Plan Review Discrepancy Report Reply Letter

Sequoia Orchard Park, Lee's Summit, MO Permit # PRES20240700

BUILDING Responses will be in order of the Comments Provided for In the Report Dated April 25

SP-1		
1	Date	APRIL 26, 2024
2	REVISION	April 30, 2024
3	REVISION	
4	REVISION	
5	REVISION

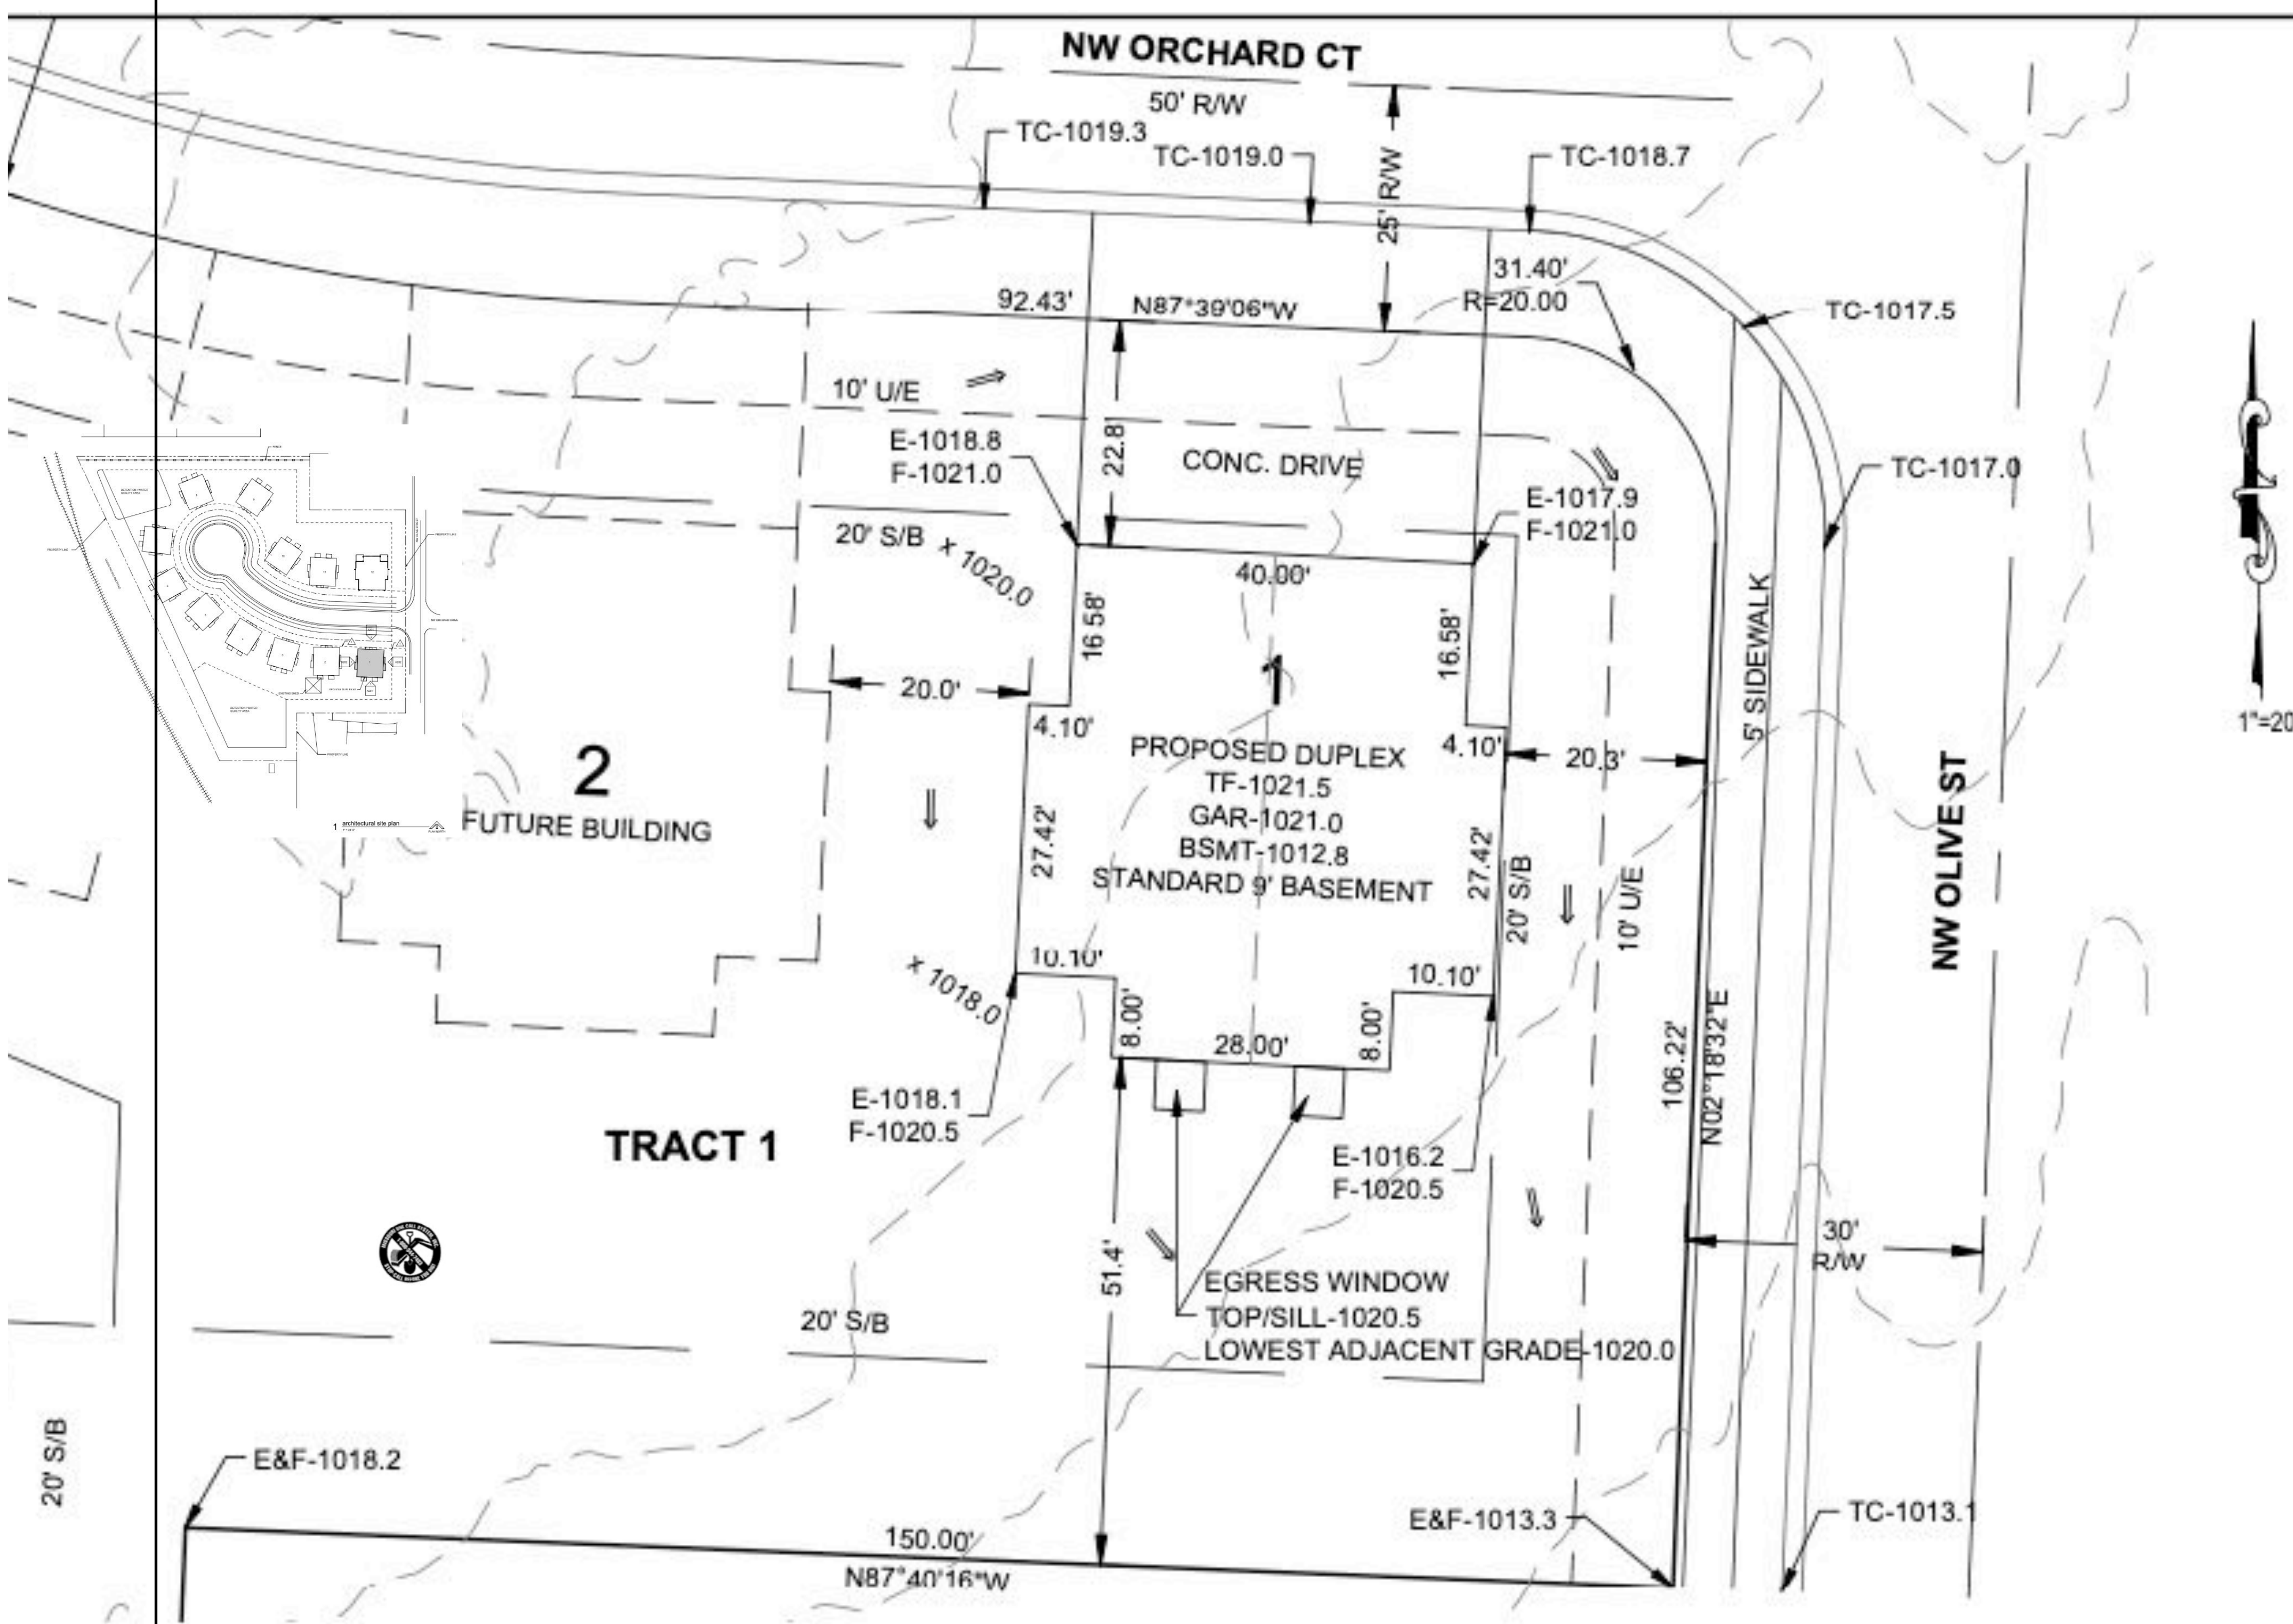
ITEM #1 I have added the proper plot plan that you send me on a SP-1 Sheet. With additional information on that sheet.

A102

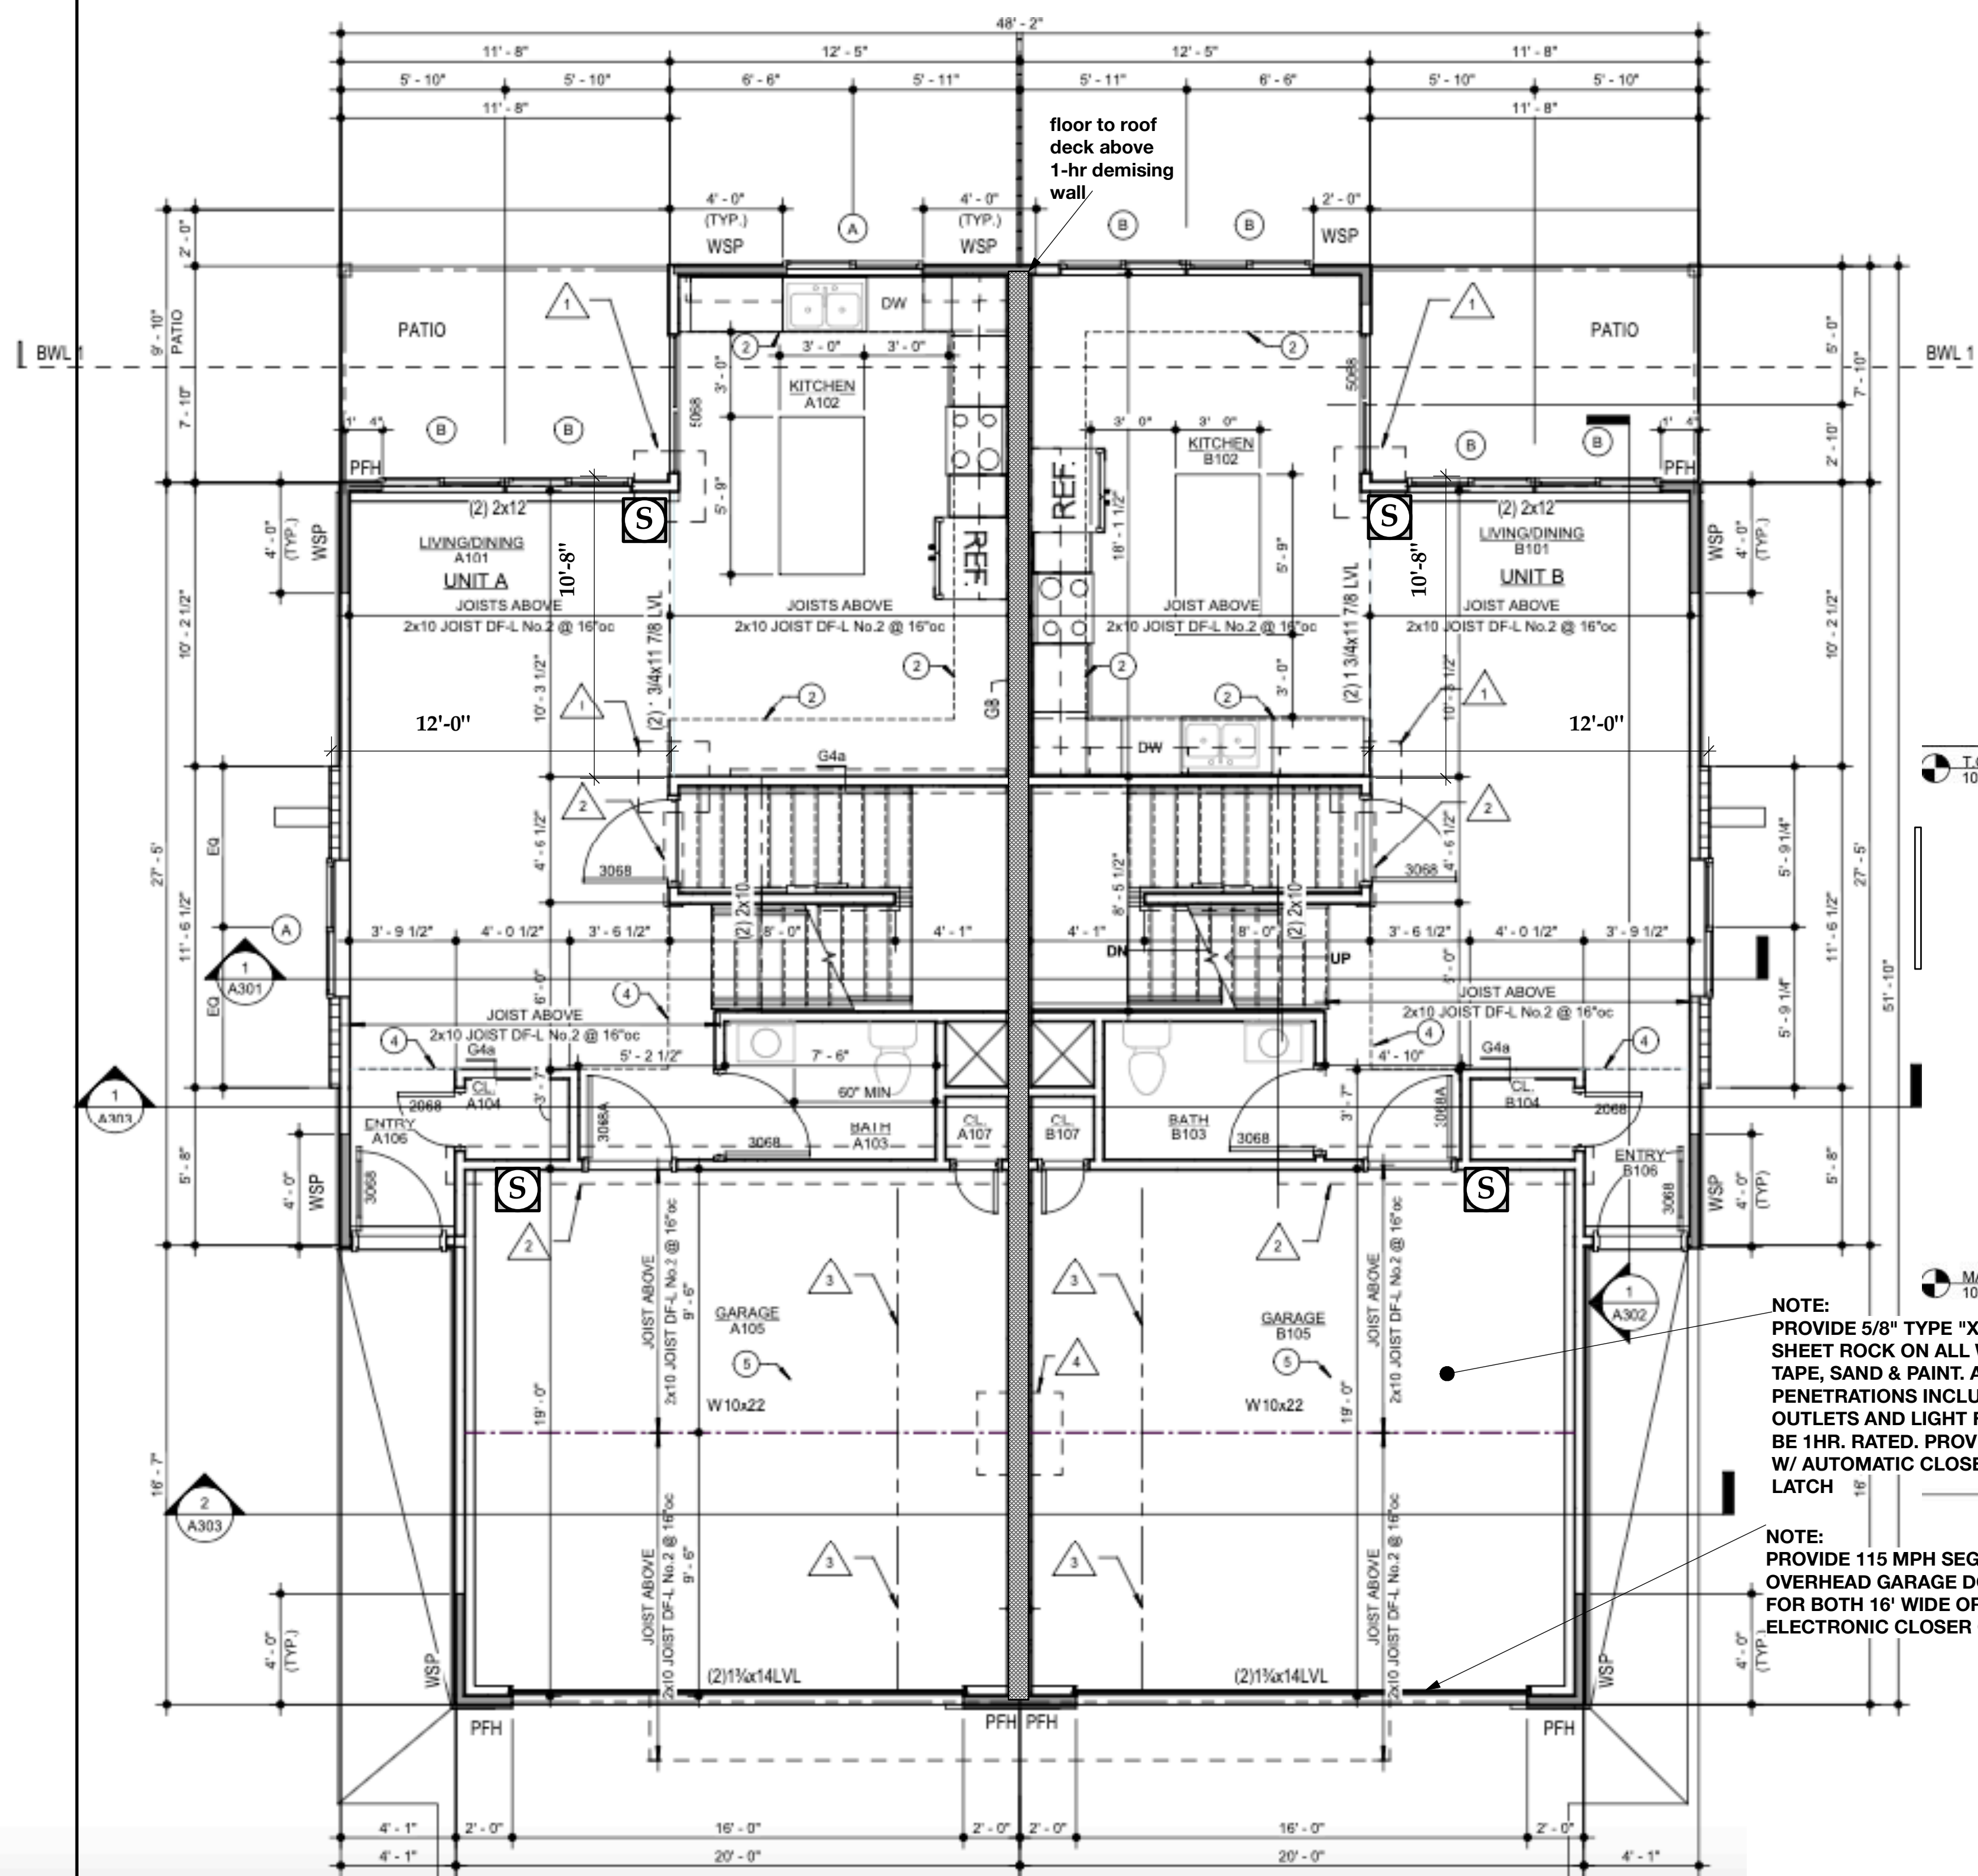
ITEM #1 The square footages are placed on the top of sheet A102 and are in both Gross and Net areas and I am sending an updated Application Form that will match the areas together from what the final plans show.
